Coastal Access Modification Report MR1

Proposed changes to the submitted England Coast Path proposals for the Minehead to Combe Martin stretch

**Locations affected:
Hurlstone Point and Glenthorne, Exmoor**

Natural England's Modification Report to the Secretary of State
July 2020

Map MR1b - Modification 1 - Hurlstone Point

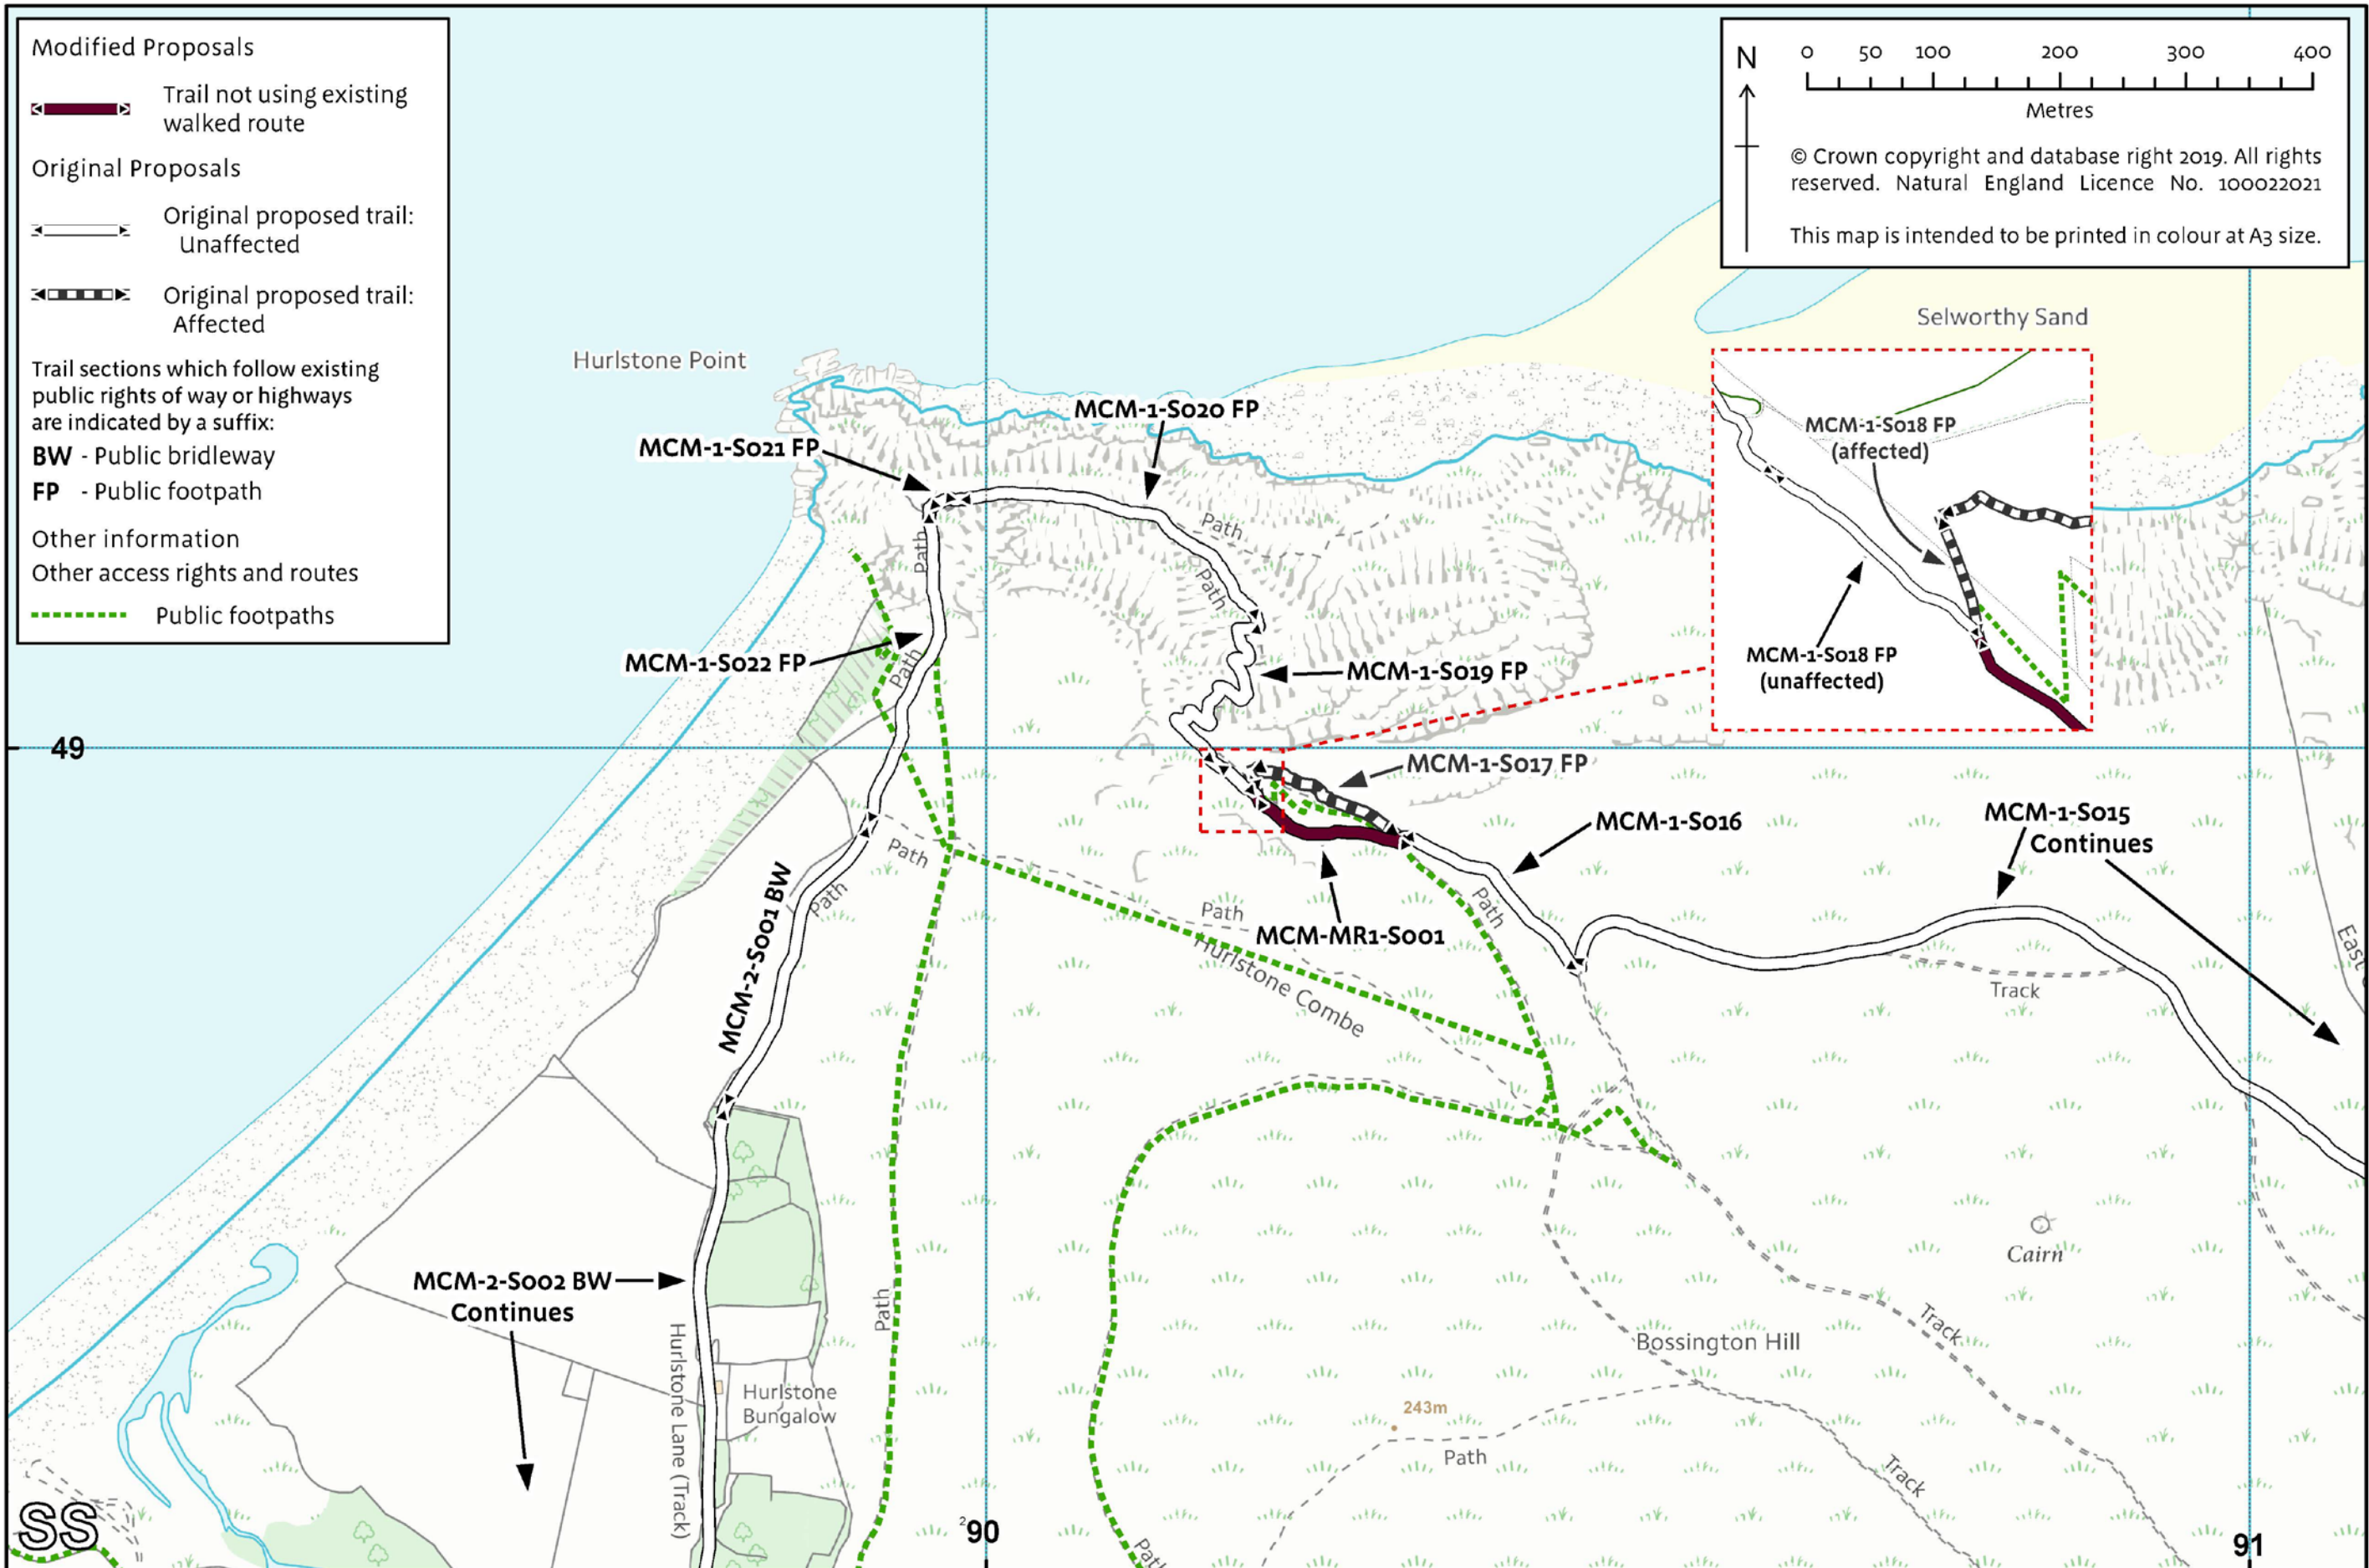
2.1.2 Following a site visit post submission, to gather information for the review of the Habitats Regulations Assessment (HRA) (see paragraph 1.2), it became apparent that a new cattle track had opened up some 20m to the west of the PRoW. This track was now being used by walkers and it seemed clear that adopting it, suitably improved, as part of the proposed ECP alignment would lead to a reduction in necessary establishment works, compared with the original proposal, and would therefore have even less impact on European Site features.

2.2.1 Our proposal (see Map MR1b) is, from east to west, to re-route the path shown as MCM-1-S017 FP and part MCM-1-S018 FB in our original report. The realigned trail would extend for a length of 90 metres at a maximum of 22 metres westward of the original route proposed.

2.2.2 The proposed route would follow an existing cattle track through the dry heath vegetation along section MCM-MR1-S001.

2.2.5 The modified proposal is to align this section of path further down the slope, below the existing walked route, where trampling by livestock has created a new desire line on the ground. The livestock path is already being used by some walkers as it avoids the rocky section and offers a more even gradient.

2.2.6 A benefit of the new proposal is that it avoids the need to install new steps within the coastal heathland. Some widening and regrading along the line of the livestock path is needed to create an improved surface for walking. The livestock path is 30-50cm in width and will be widened to 1m by lifting turf on the higher (north east) side of the path and placing on the lower side. The length of the modified section of route is approximately 90m in length and the area of habitat affected is small in the context of the site. Being a shallower gradient, the surface of the new section of path is less likely to become eroded. Walkers will be directed along the new alignment and as a result, use of the existing walked line will decrease, allowing heathland vegetation to recolonize. The overall potential impact on the heathland habitat will reduce as a result of the modified proposal.

- The cattle track will need manually widening to 1 metre by lifting turf on the higher (north east) side of the track and placing on the lower side. Some additional manual work will be required to level the surface along part of the new length

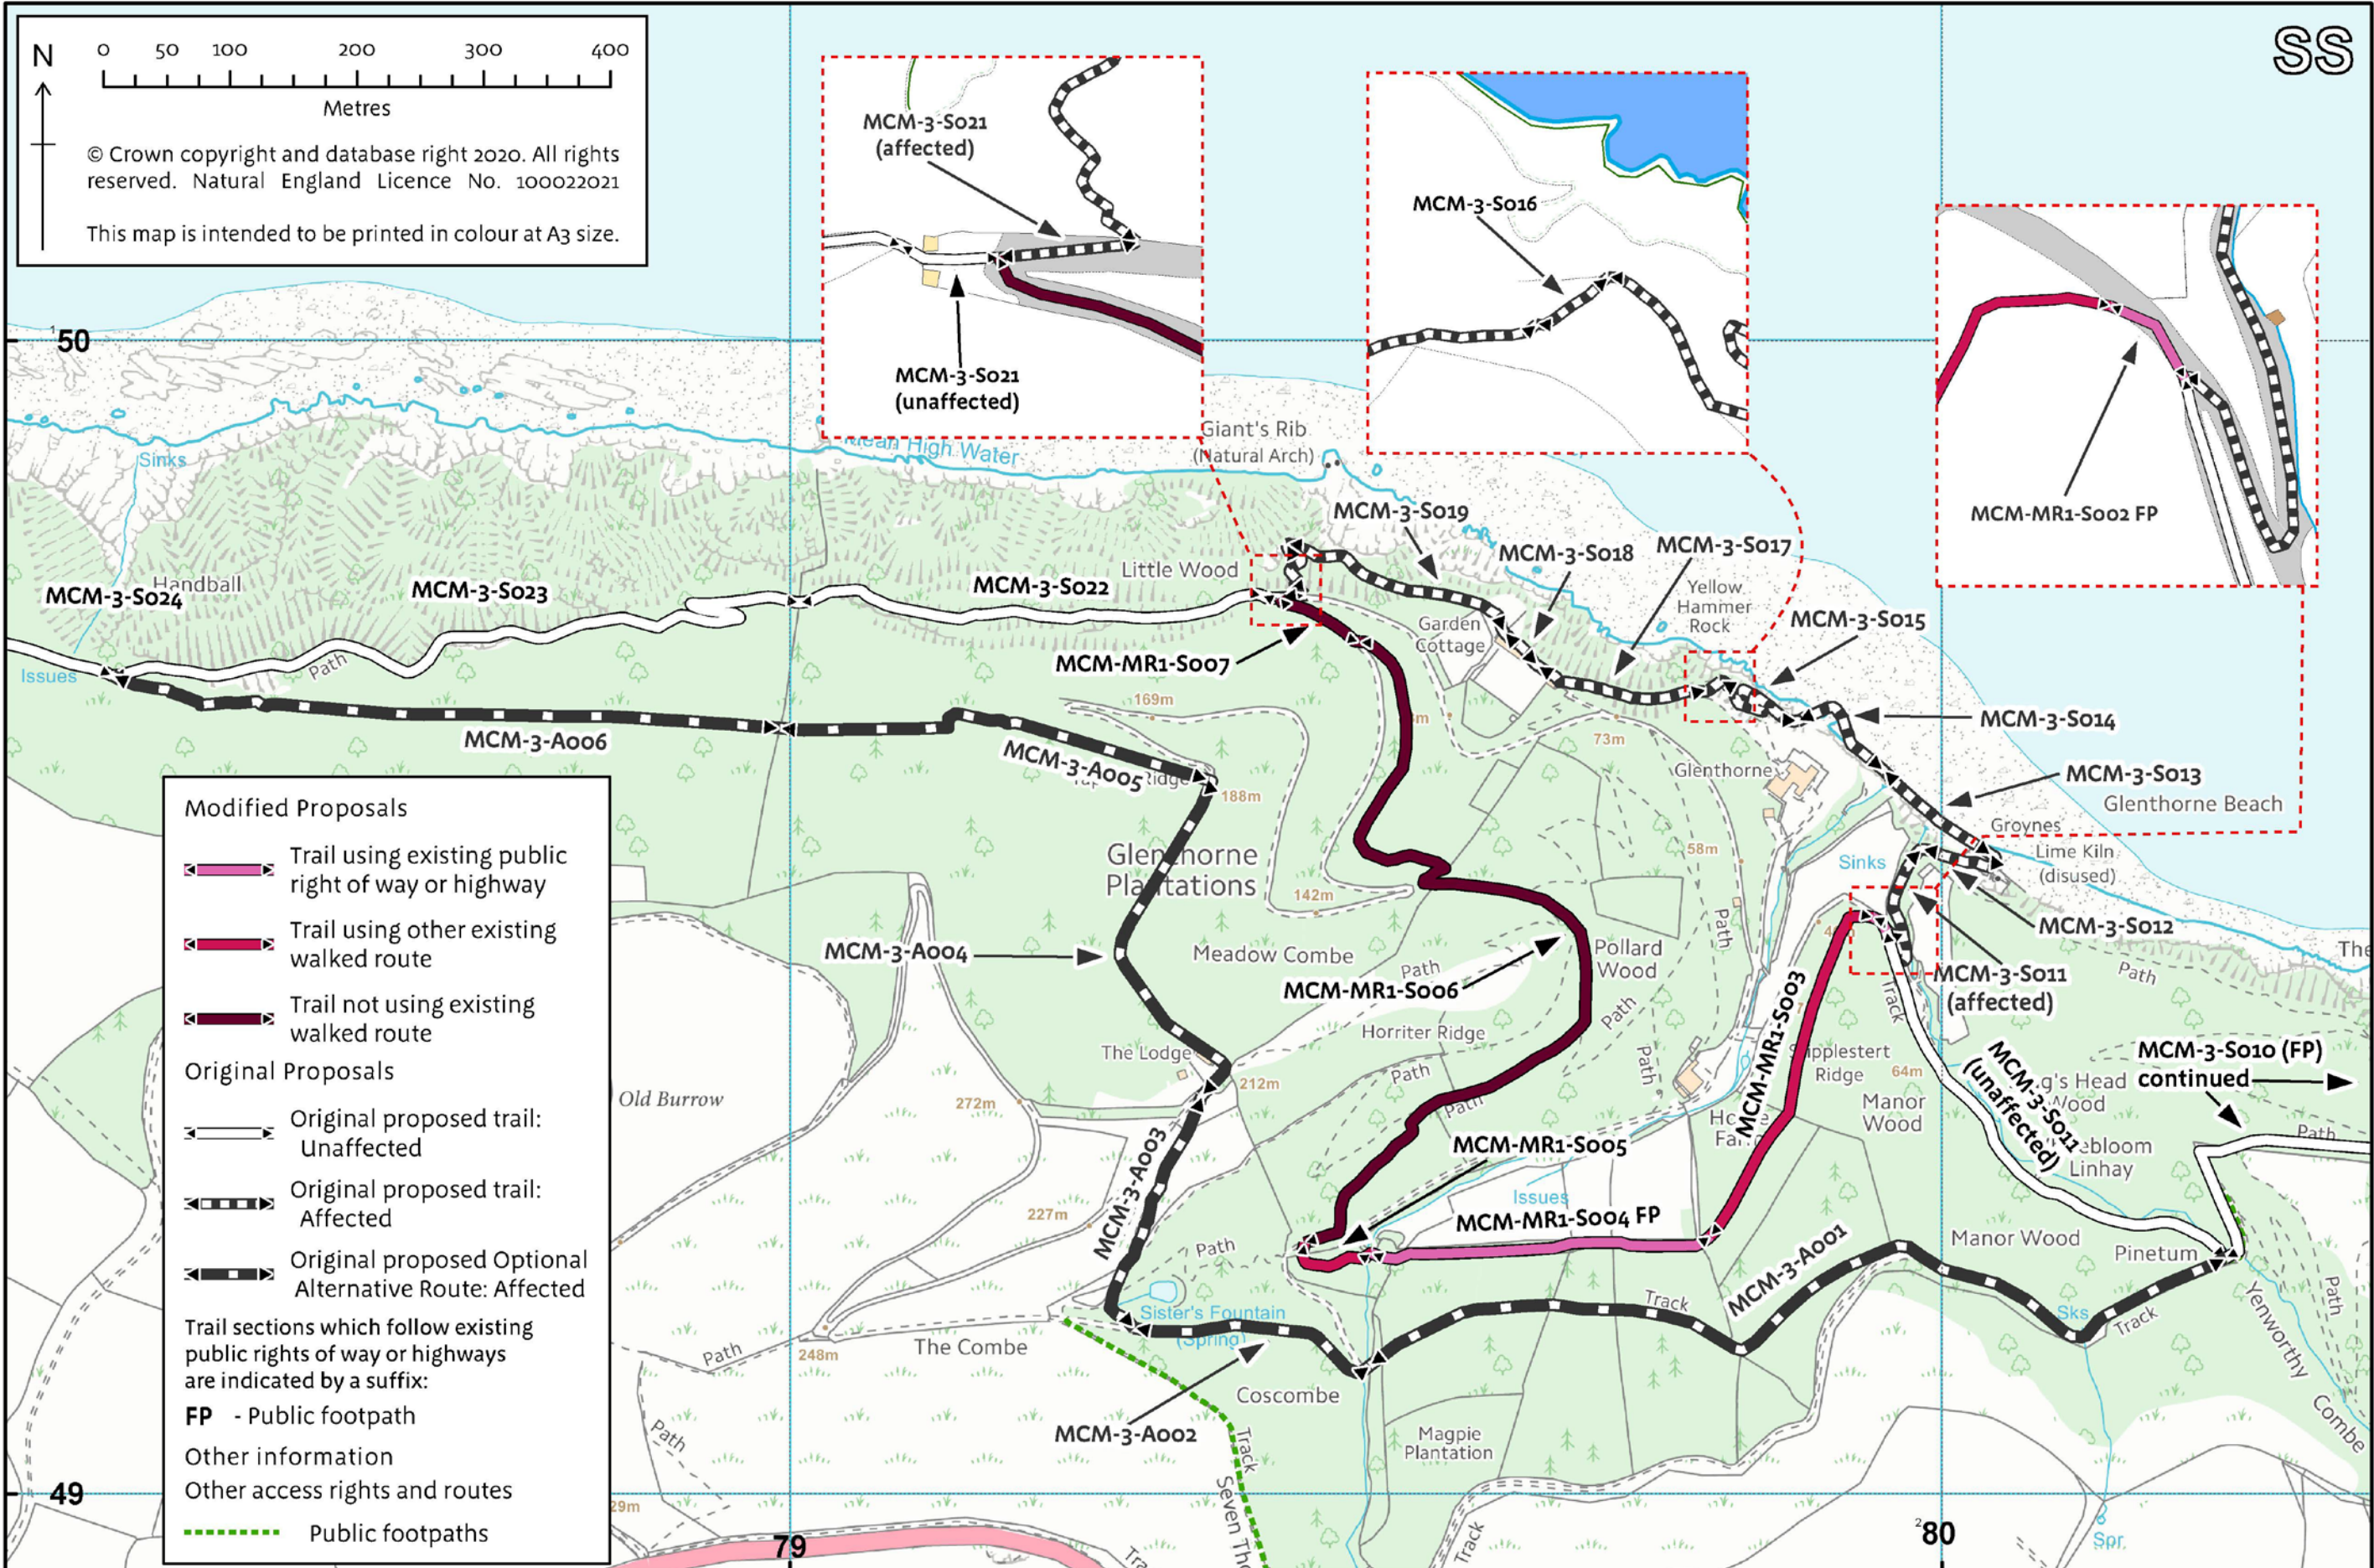
3.1.2 However subsequent to submission of the proposals, ownership of Glenthorne House and Estate has changed and the new owners do not want to dedicate a route through the gardens in this way. As the gardens extend to the cliff top, this makes it impossible to identify a route for the coast path to the seaward side of the buildings and other excepted land.

3.2.1 Our proposal (see map MR1c) is, from east to west, to re-route the path between Yenworthy Combe to the east of Glenthorne House, and The Towers at Little Wood to the west of Glenthorne estate (route sections MCM-3-S0011 to MCM-3-S0021 of our original report).

3.2.2 The proposed route would follow an existing walked route (a permissive path known locally as 'Ben's Path') along sections MCM-MR1-S003 and MCM-MR1-S005 and a public footpath along section MCM-MR1-S004 to a track. It would then follow a new path, not used as an existing walked route, through woodland along sections MCM-MR1-S006 and MCM-MR1-S007, to a point where it would join the previously submitted route at The Towers.

- The surface of part of the proposed route is currently not walked and requires some improvement to create a suitable path, including vegetation clearance and levelling.
- A number of new signs would be needed on the trail.
